Access Compliance Report

Public Rights-of-Way

(Curb Ramps)

| Intersection ID: 13263 | Main Street: MCCLINTOCK_RD | Cross Street: THE_PLAZA | Location: NE |

| ADA ID: D0209FBCD3E2 | Ramp Type: Perp | Initial Pass/Fail: Fail | Overall Compliance: No |

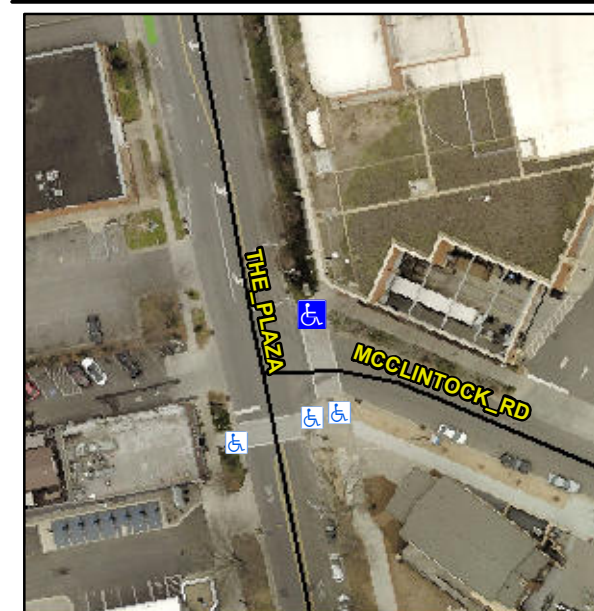
Remove & Replace Entire Ramp.

R304.2.2

| Compliance | Description | Data | Compliance | Description | Data |
|------------|-----------------------|-------|------------|-----------------------------|------|
| N/A | Ramp Length (in) | 95.0 | No | Ramp Slope (%) | 8.4 |
